STATE OF OHIO
DEPARTMENT OF TRANSPORTATION

HAM-75-1.95

REVIEW COMPLETE

RECONSTRUCT AND WIDEN I-75 FROM JUST NORTH OF THE FINDLAY ST. OVERPASS TO JUST SOUTH OF THE MARSHALL ST. OVERPASS. PROJECT INCLUDES THE RECONSTRUCTION OF THE WESTERN HILLS VIADUCT INTERCHANGE THAT WILL CONNECT THE NEW WESTERN HILLS VIADUCT (WHV) TO I-75. THE WHV PROJECT IS BEING DEVELOPED AND CONSTRUCTED BY THE CITY OF CINCINNATI UNDER PID 105349.

INTERSECTION DETAILS
HARRISON AVE AND WINCHELL AVE/CONNECTOR

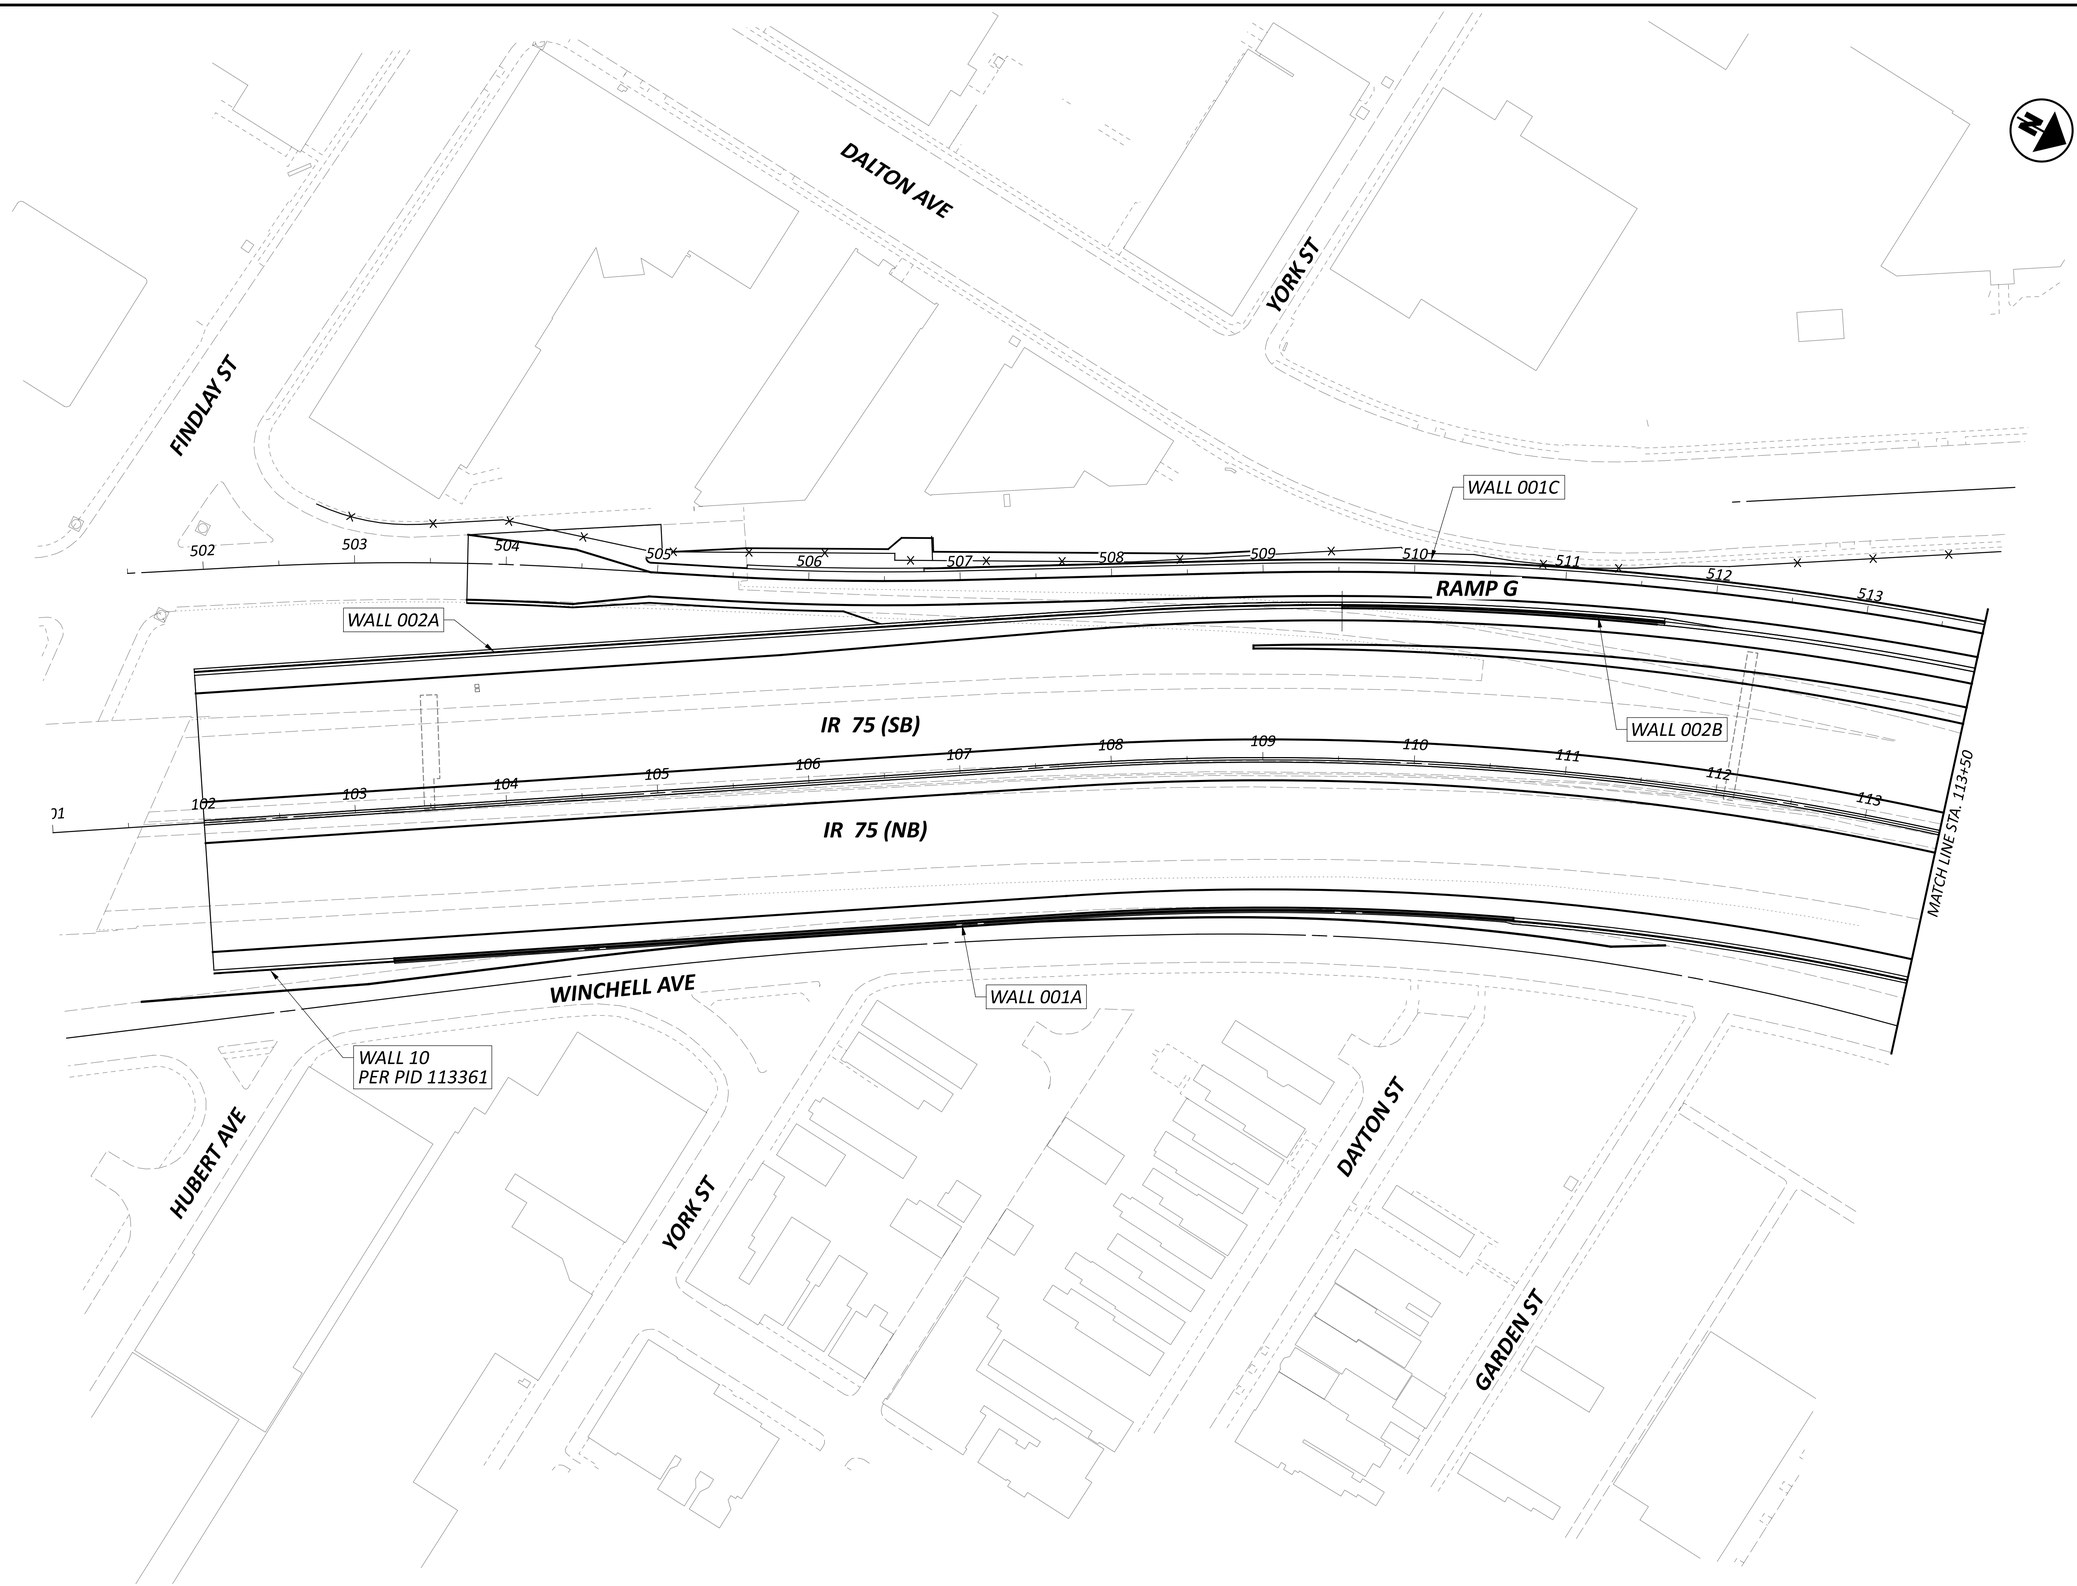
On Sheet #53 the elevation @ Sta. 16+00 is 508.09. If that profile elevation is correct this intersection detail needs to be updated. Other locations on the Connector baseline appear to differ from Sheet #53..
